REGIONAL REVIEW NOTIFICATION

Name of Proposal: 1125 Peachtree (DRI 2821)

1125 PEACHTREE STREET DRI City of Atlanta Natural Resources Group Review Comments August 1, 2018

Assessment of Consistency with the Regional Transportation Plan

#2821

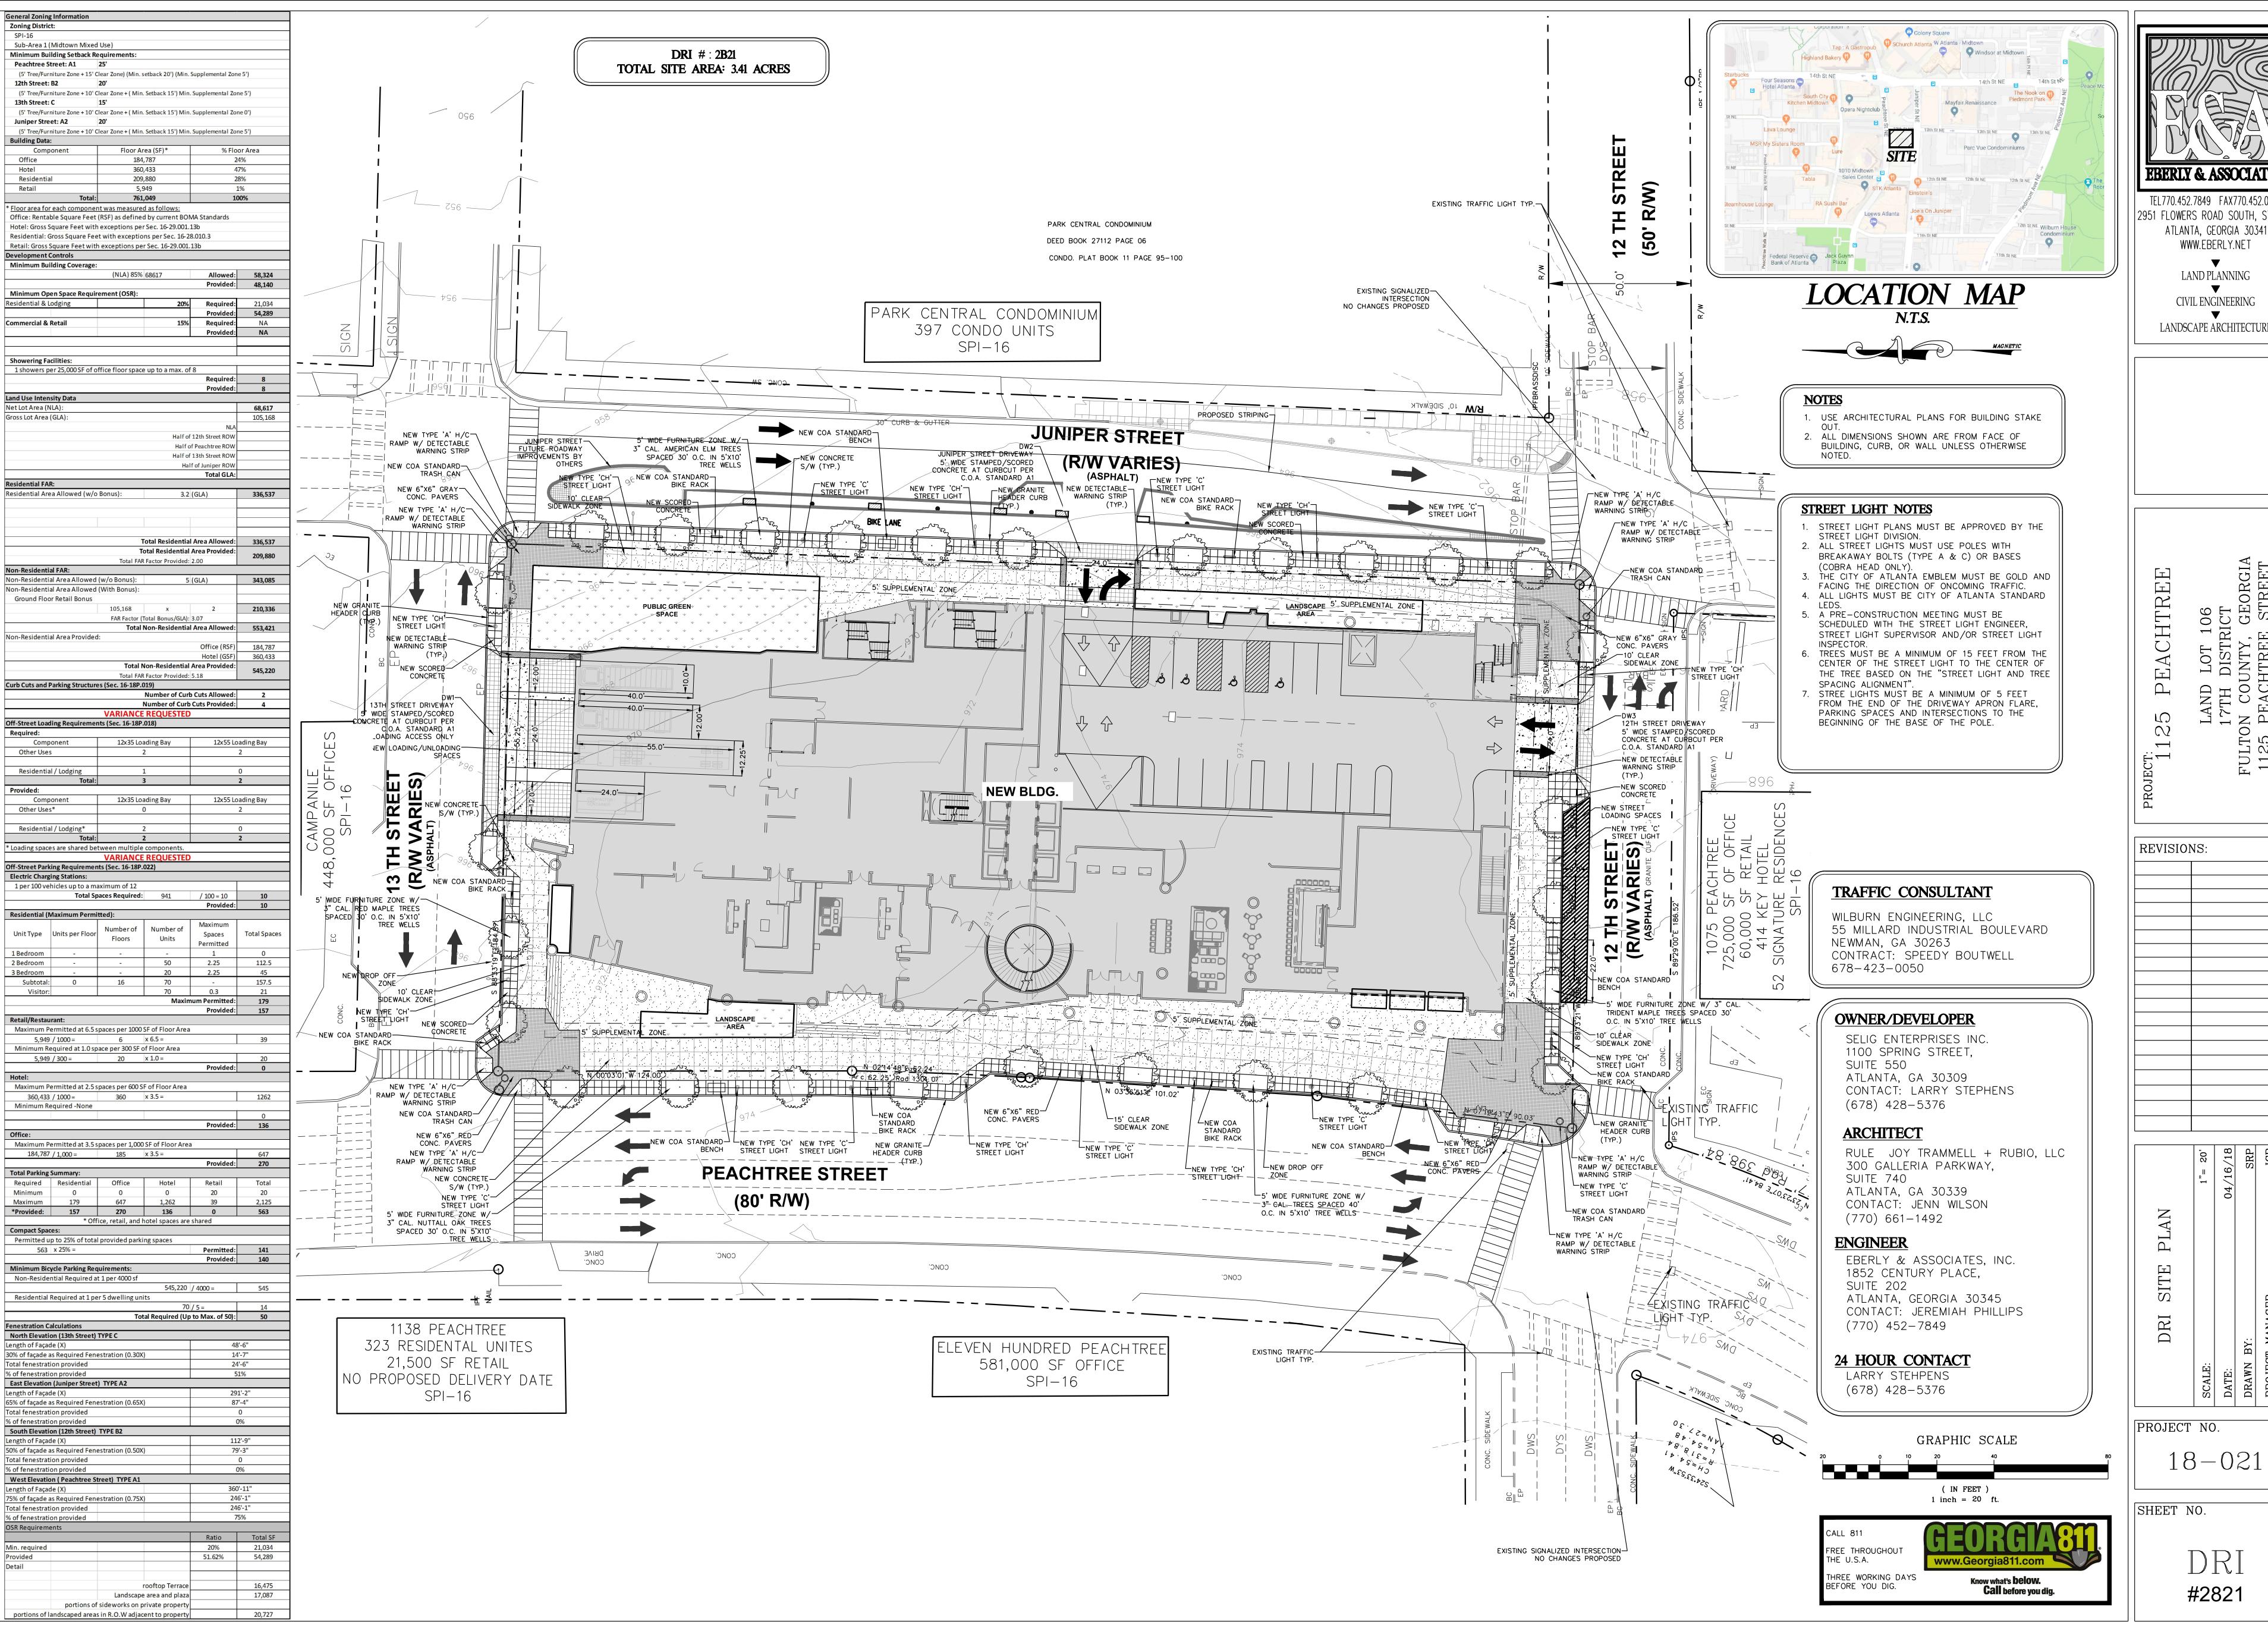
To capitalize on this potential, care should be taken to ensure that the development, as constructed, promotes an interconnected, functional, clearly marked and comfortable pedestrian experience on all streets, paths and parking areas. As submitted, the DRI site plan shows significant pedestrian and streetscape improvements to all four sides of the project, and it incorporates the planned Juniper Street bike lane on the east frontage of the site. The development team is also encouraged to ensure that end-of-trip facilities (bicycle racks, etc.) are provided for residents, workers and visitors at key locations throughout the

site. The project can further support The Atlanta Region's Plan in general by incorporating other aspects of regional policy, including green infrastructure and/or low-impact design, e.g., rain gardens, vegetated swales, etc., in parking areas and site driveways, and as part of any improvements to site frontages.

The USGS coverage for the project area shows no streams on or near the property. No streams or other waters of the State are shown on the submitted site plan and no evidence of streams or other waters is visible in available aerial photo coverage. Any unmapped streams identified on the property may be subject to the City of Atlanta's stream buffer ordinance. Any unmapped State waters identified on the property will be subject to the State 25-foot Sediment and Erosion Control buffer.
